Catherine Townend
National Highways
Your Reference: NHPR 22-12
By Email

20/08/2024

Proposed Construction of Motorway Service Area at South/Western Boundary Fronting M69, Land East of Stretton Croft, Wolvey Road, Leicestershire.

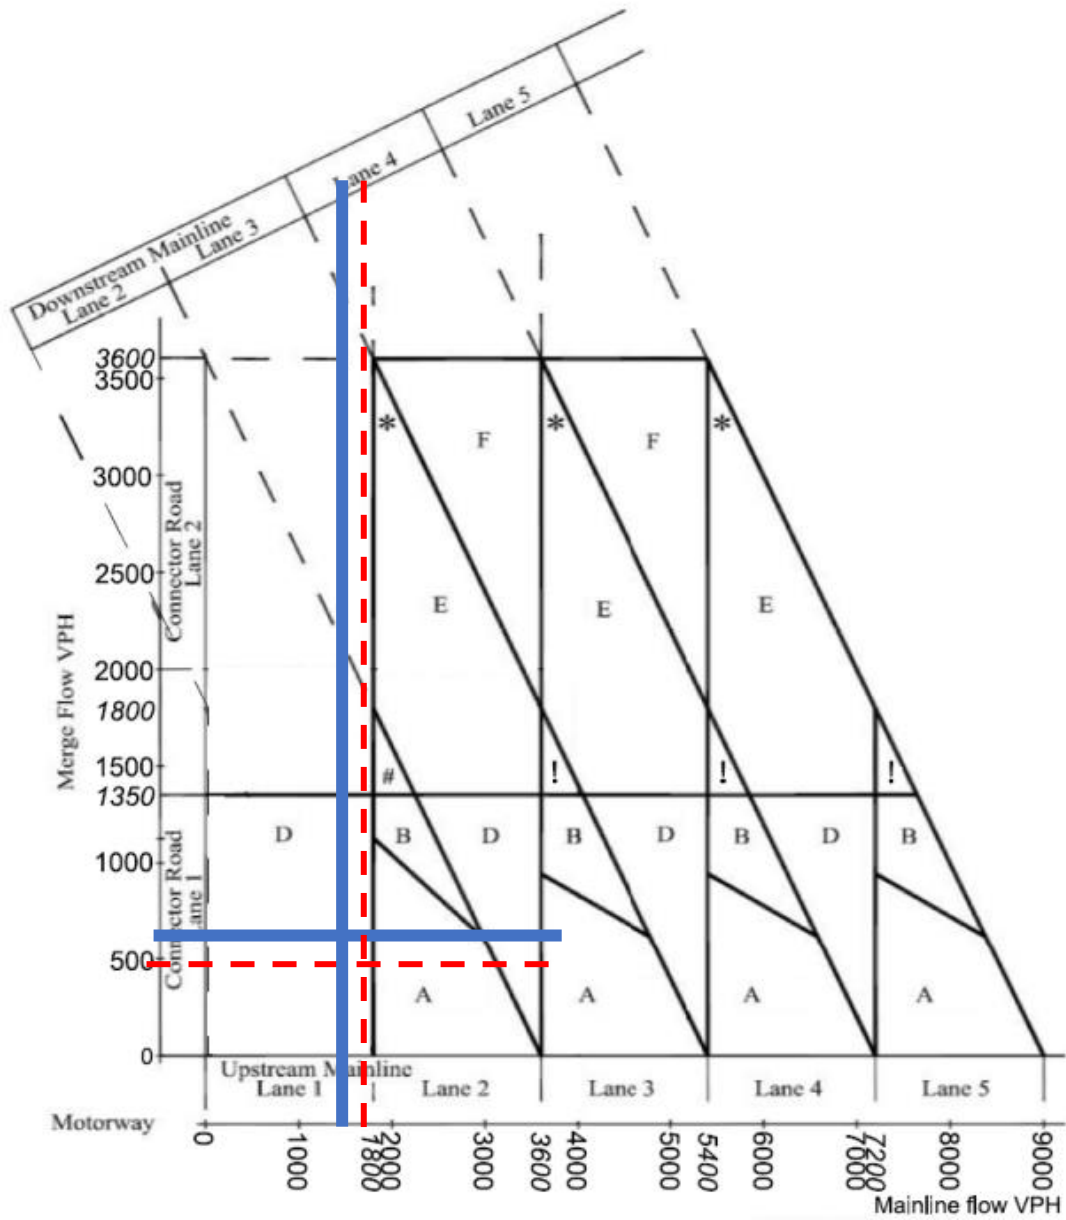
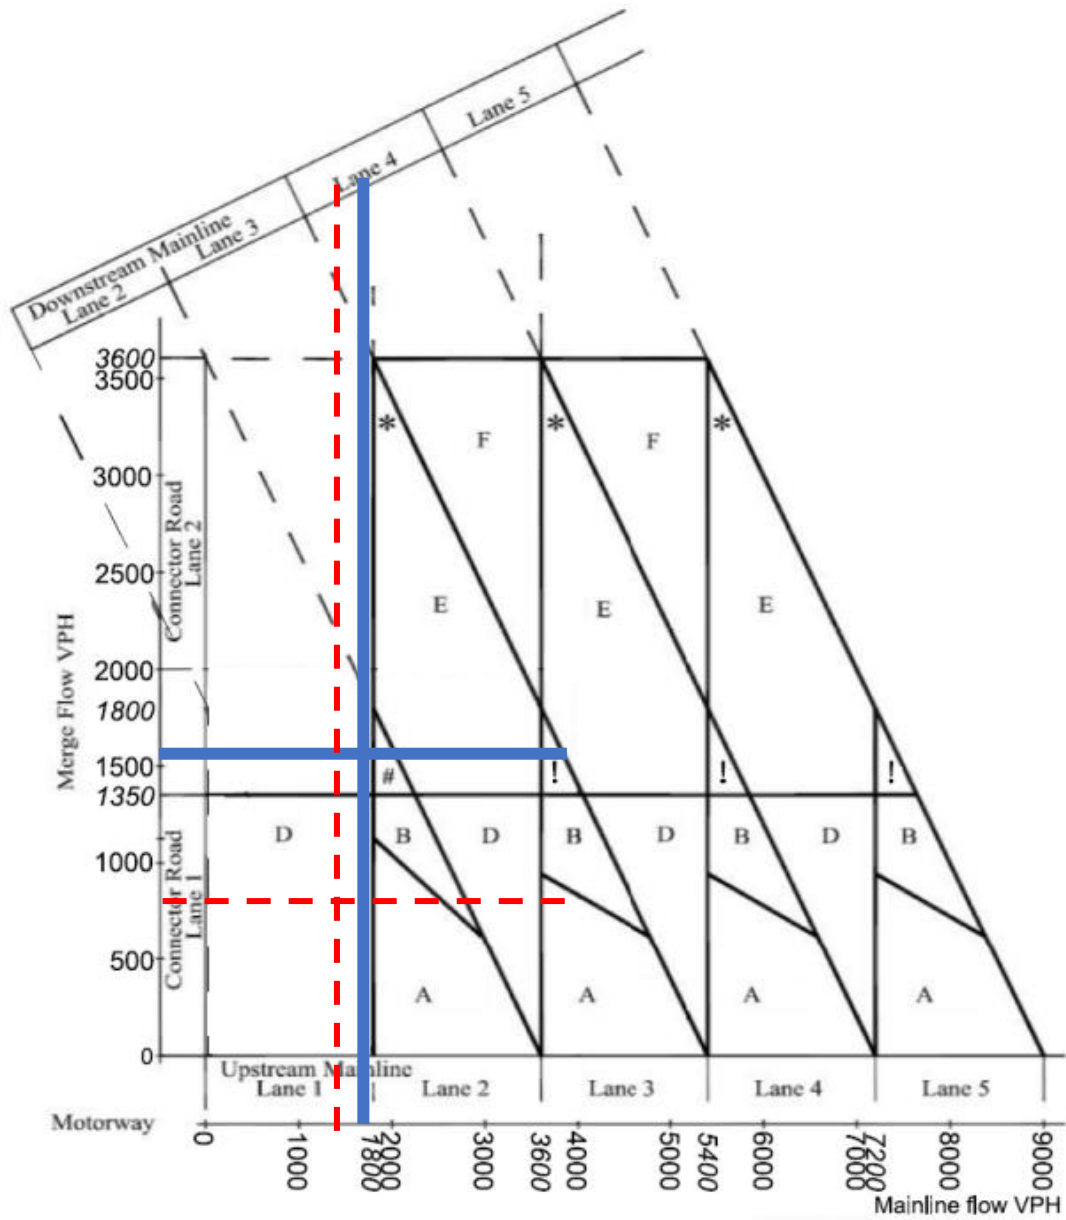
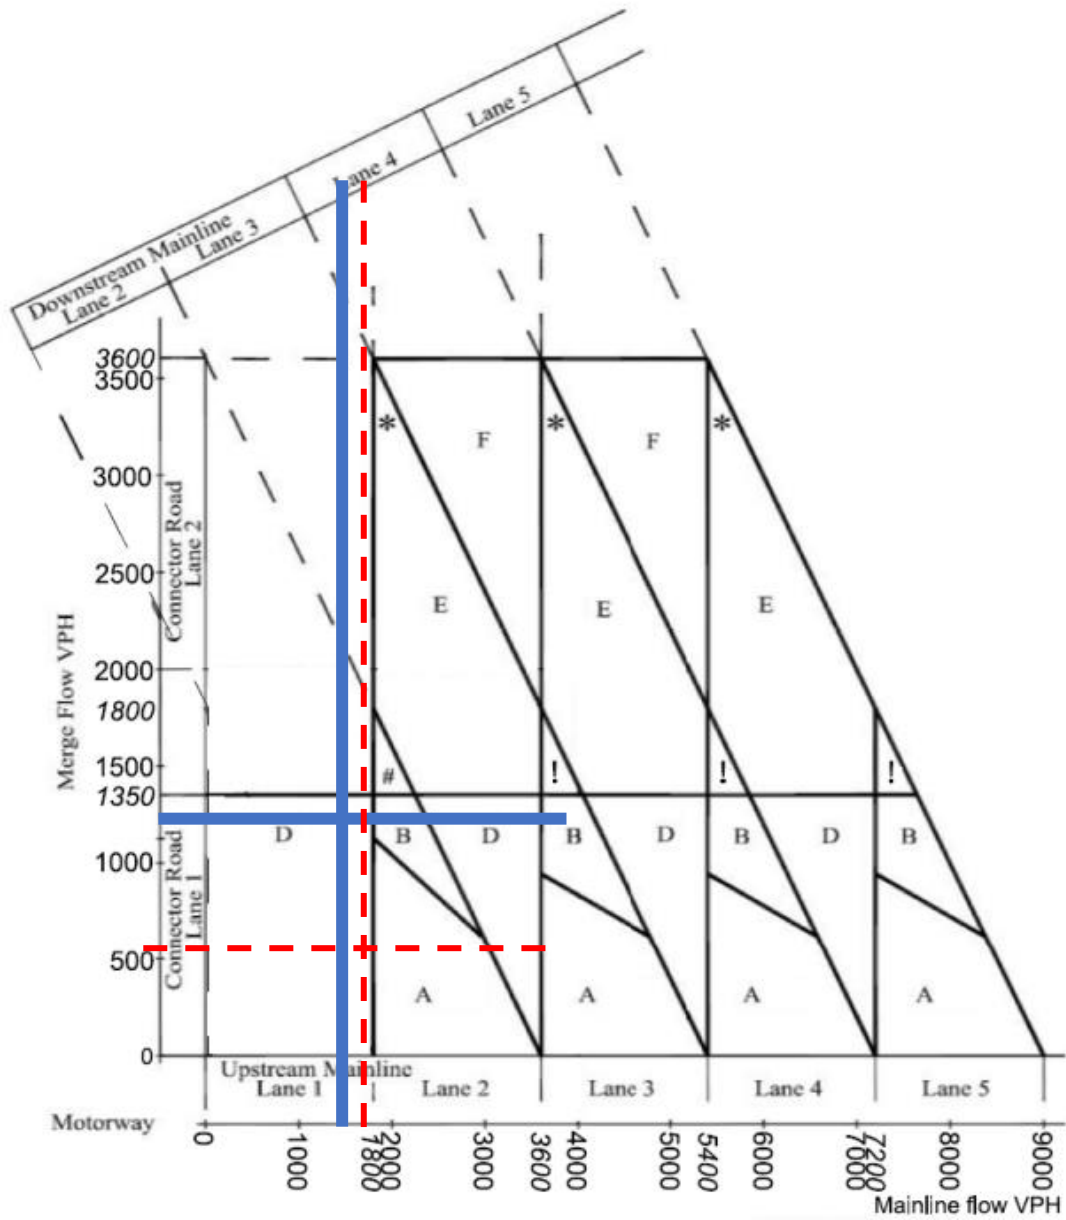
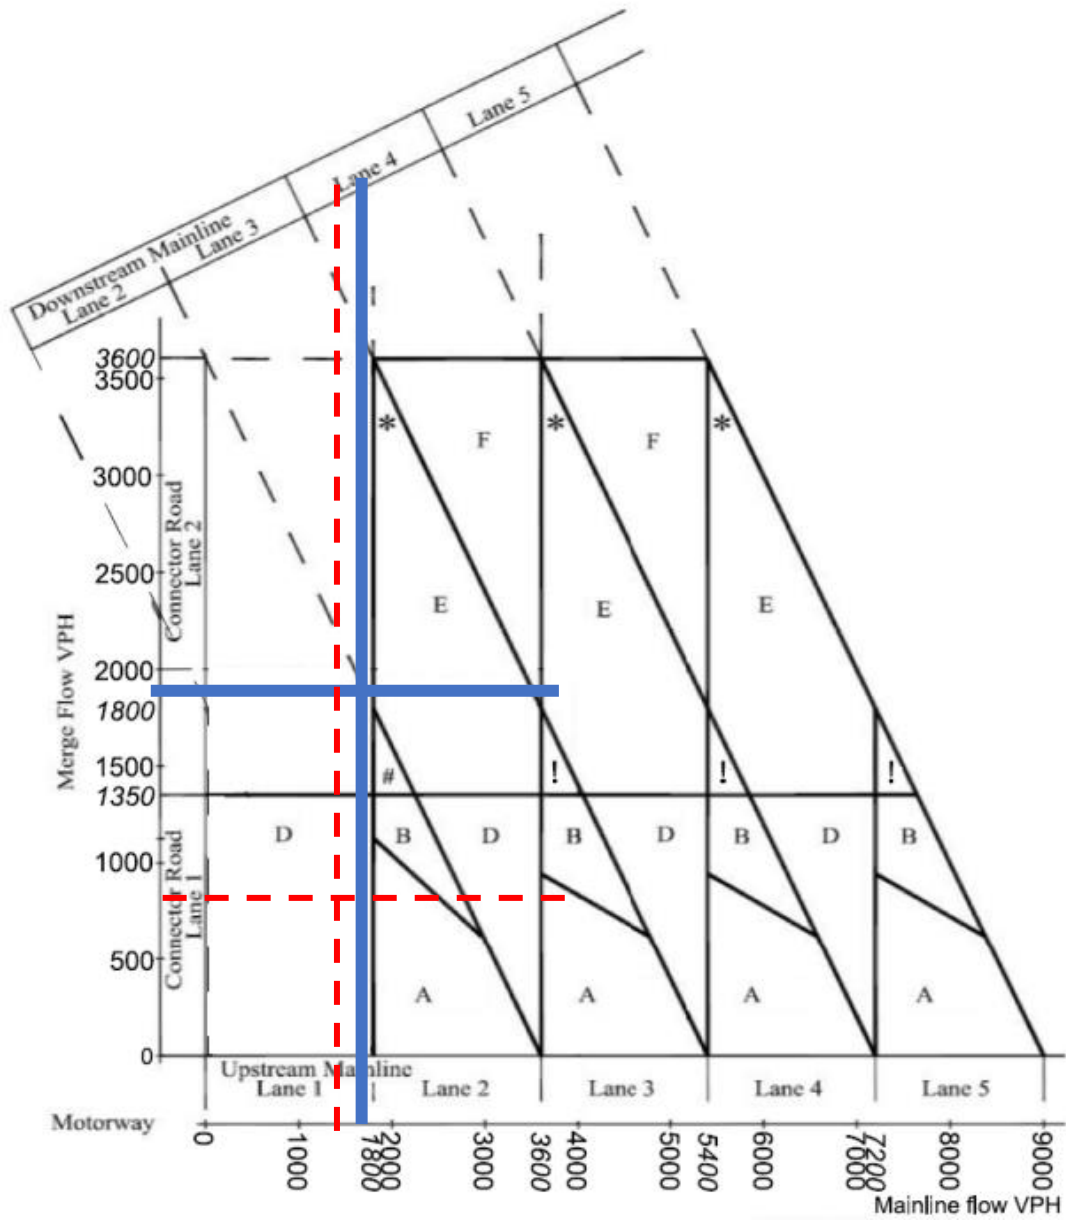
The above commentary does not consider whether the increase in traffic using the merge/diverge (as a result of the proposed development) would require a step change in layout compared to the current design. Using the information from the Appendix 7 of the TA we have created the below table. This indicates that the NB and SB merges would be below the required layout. The applicant should consider the requirement to bring the merges up to the required standard. If they do not think this is necessary, they should explain why.

M69		Required (AM Peak)	Required (PM Peak)
Merge/Diverge	Existing Layout		
NB Merge	Type A	Type D	Type D
NB Diverge	Type A	Type A	Type A
SB Merge	Type A	Type D	Type D
SB Diverge	Type A	Type A	Type A

It is noted that the existing situation at the site is a Type A merge and that the results of the Merge/Diverge assessment for both scenarios demonstrate that both the NB and SB merges should be Type D. Therefore, the addition of the development related traffic is not the cause of the change in the required standard of junction type, given that the existing situation should already be Type D.

Whilst Type D suggests the requirement for a lane-gain, given the low mainline flows, this would typically be for a one lane upstream approach to proceed with two downstream lanes. The existing situation already has three upstream lanes and three downstream lanes, and it is therefore not considered that a lane gain would be required in this situation. The chart would suggest that both merges will only ever be required as Type D as the mainline flow does not exceed 2,000 vph. Therefore, the junction already provides more capacity than the chart suggests is required and we consider this matter resolved.

Client	Welcome Break			
Project	Proposed MSA Development Stretton Point, Hinckley			
Drawing Title	Potential Site Access Arrangement Swept Path Analysis 16.5 & 15.5m Articulated Vehicles			
Date	August 2024	Scale	As Specified @ A1	
Drawn	BF	Approved	GS	
Drawing Number	DTP/3711622/SK004			Rev. D

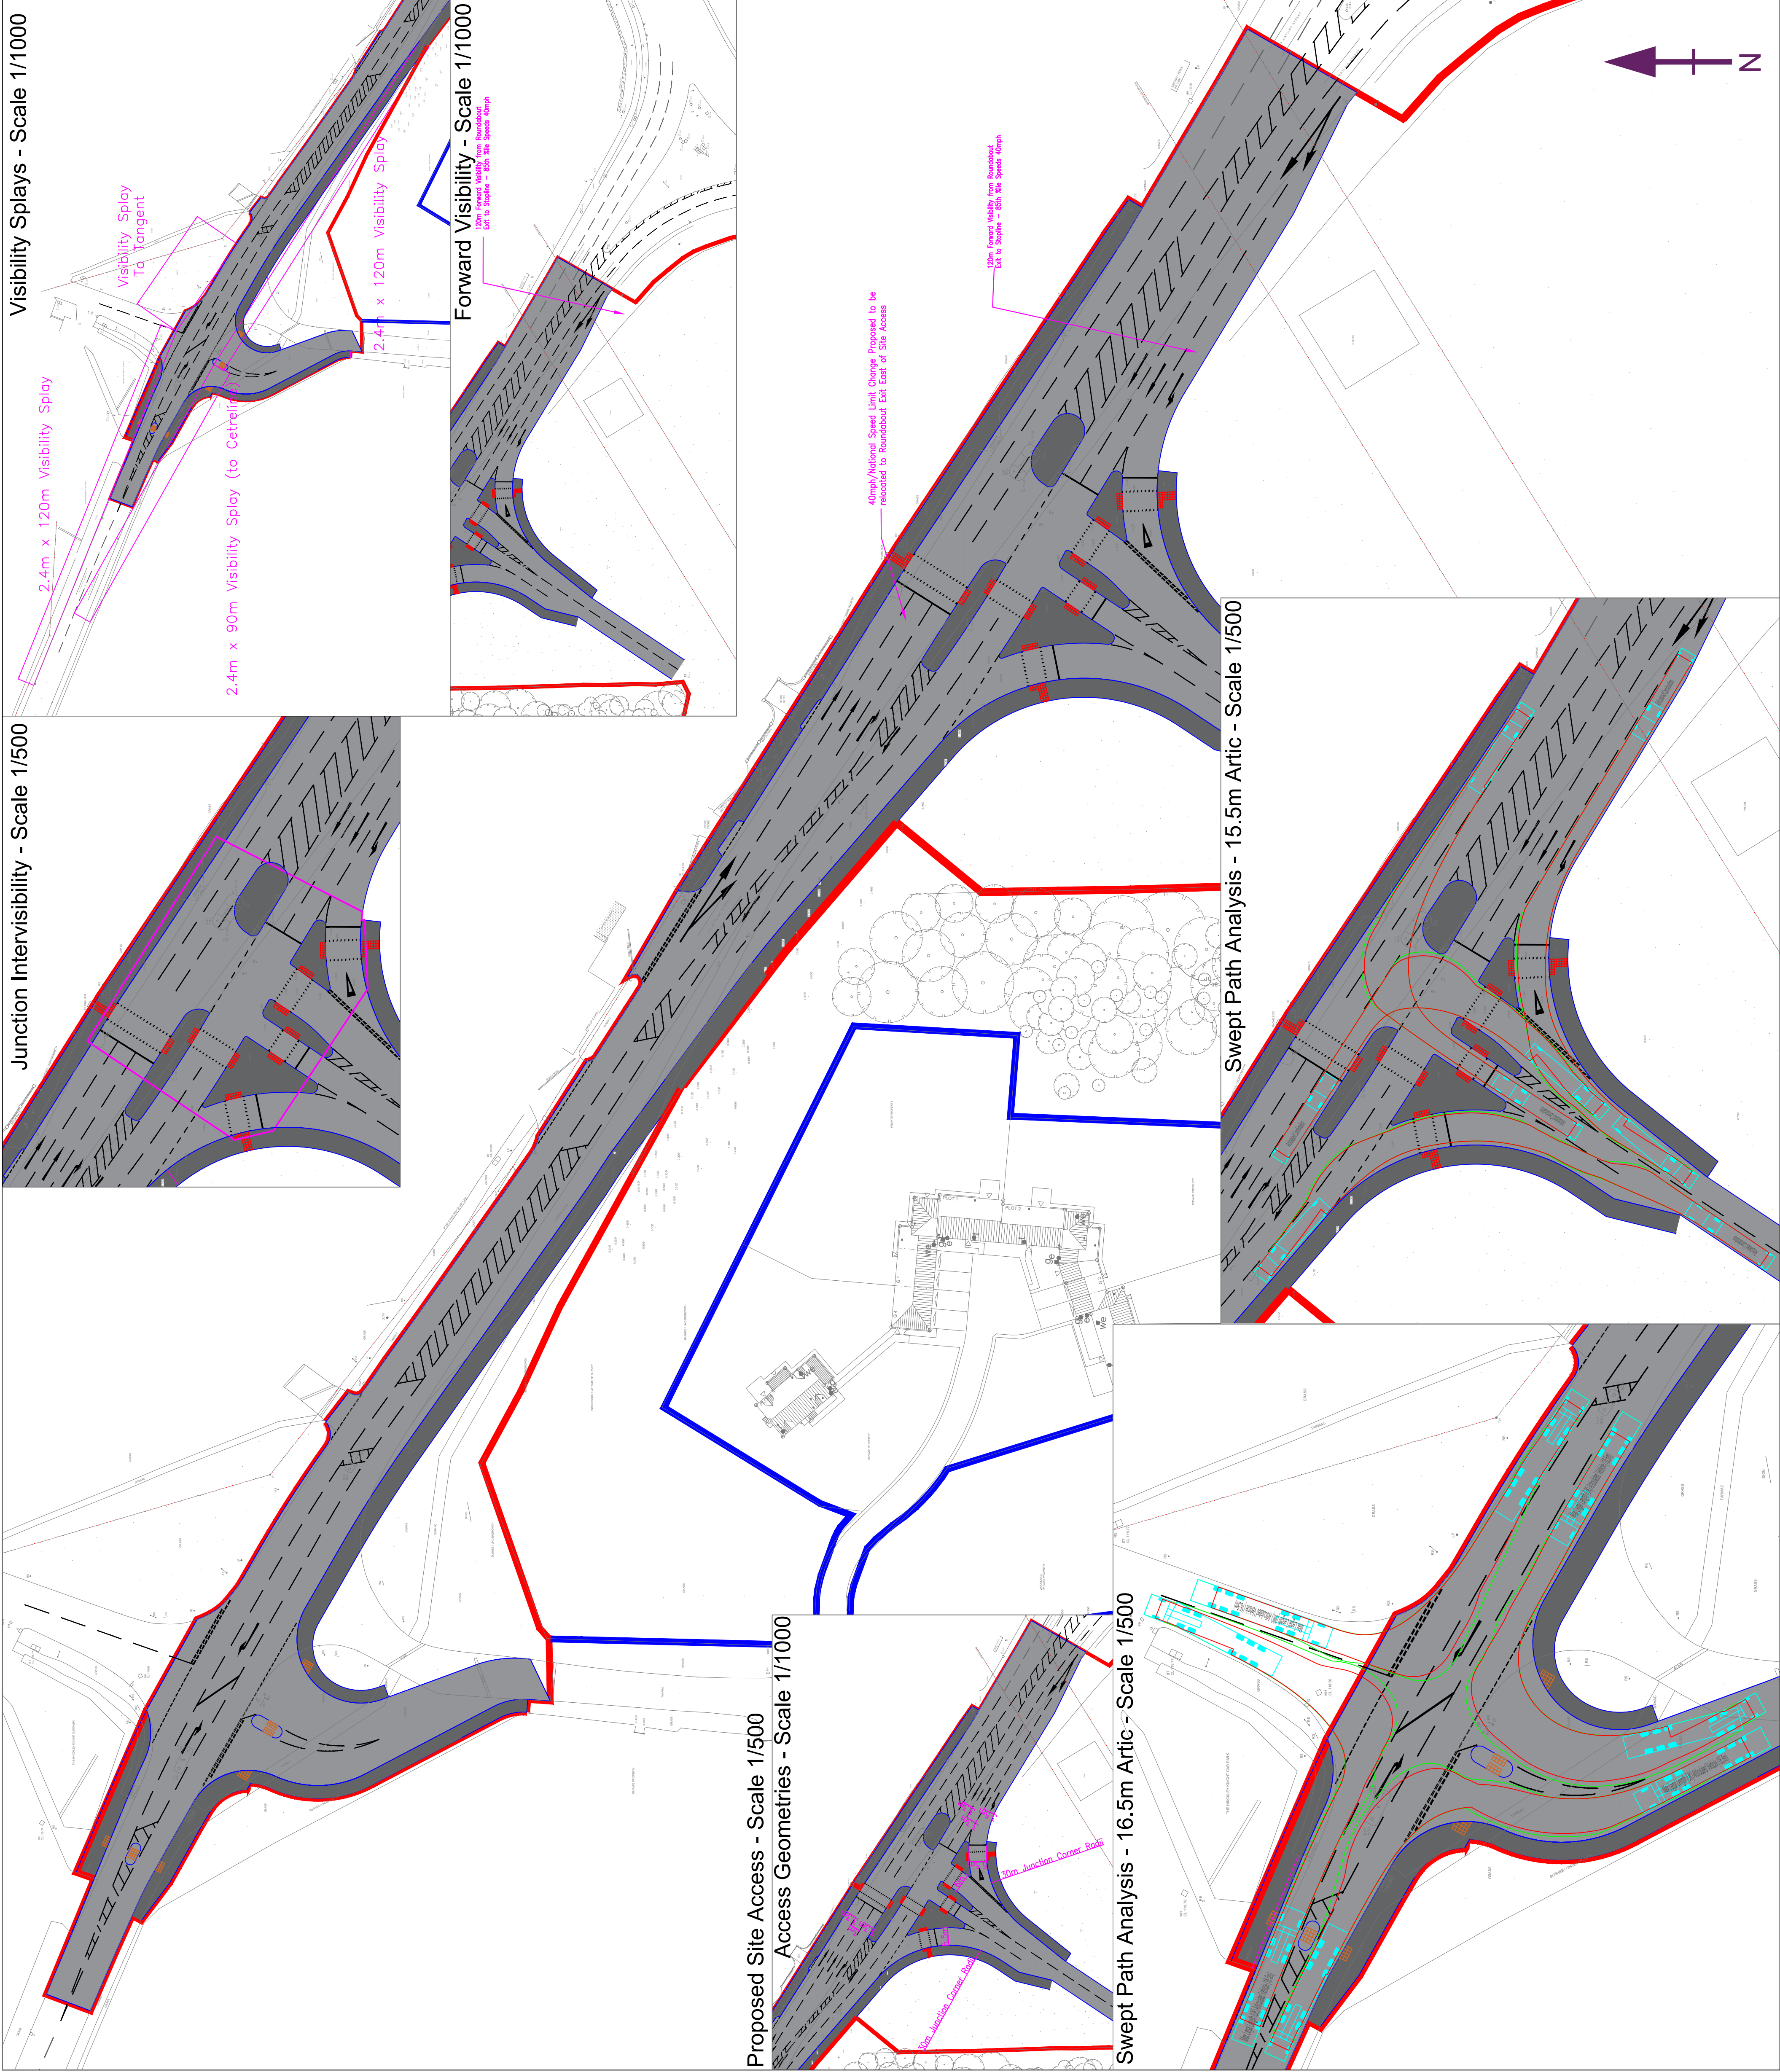
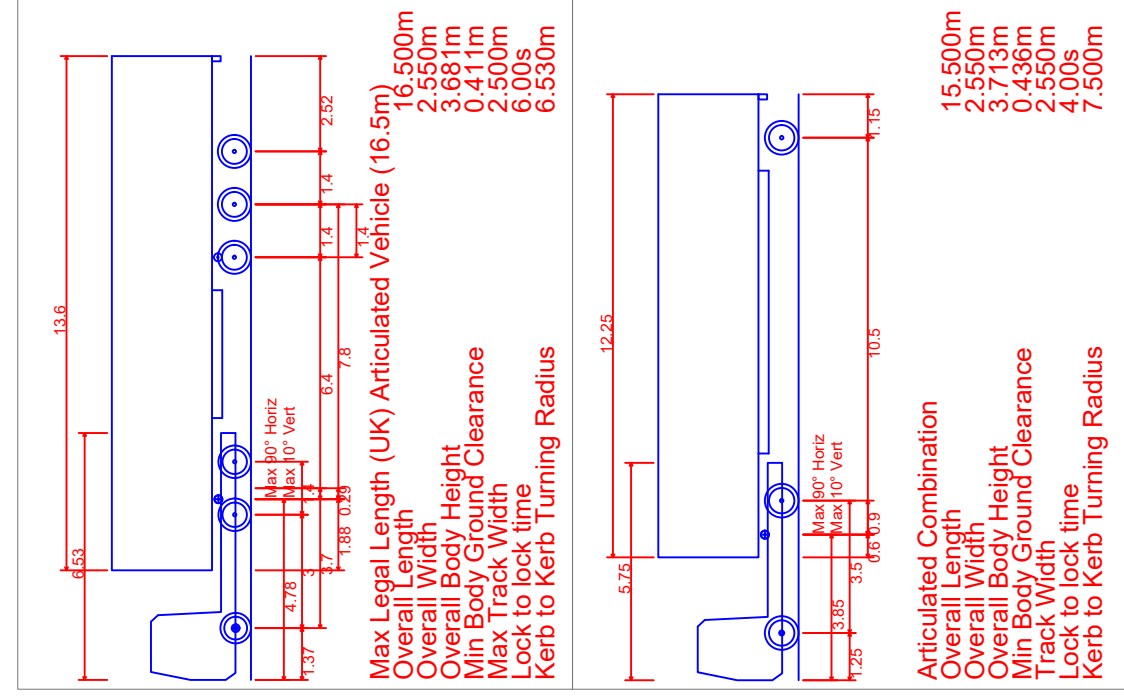
Site access layout – needs to be designed to a preliminary design standard (General Arrangement drawing) as per DMRB. More information on this can be found in [Planning for the Future: A Guide to working with National Highways on Planning Matters \(Oct 2023\)](#) – in particular, please refer to Page 21. **Please note for the avoidance of doubt, the above requirement will apply to the Wolvey Road junction works and any additional off-site mitigation (if required).**

- General Site Access Arrangement (Drawing DTP-3711622-SK004-D) – Inclusive of the proposed site access arrangements, relevant dimensions and geometries, junction intervisibility and vehicle swept paths.
- Highway Boundary Plan (Drawing DTP-3711622-SK010-A) – Depicting the boundaries of the applicant's ownership and the extent of the application site.
- Highway Level Arrangement (Drawing DTP-3711622-SK005) – Denoting the relevant levels within the vicinity of the proposed site access.

In addition to the above drawings, a summary of the required DMRB standards and the achieved measurements for the proposed site access are presented in the table below. The table demonstrates that the proposed site access arrangements achieve the stipulated DMRB design requirements.

Item	Requirement	Design
Angle of Intersection	70 - 90 degrees	90 degrees
Forward visibility to stoplines	40mph speed limit and recorded speeds = 120m	120m
Junction intervisibility	Shown on plan	achieved
Lane widths	3m min - 3.65m max	3.3m
Turning lane storage requirements	meet capacity and queuing requirements	achieved
Exit lane continuity	100m	100m
Corner Radii	designed to accommodate swept paths (NH specifically requested 15.5m artic)	achieved
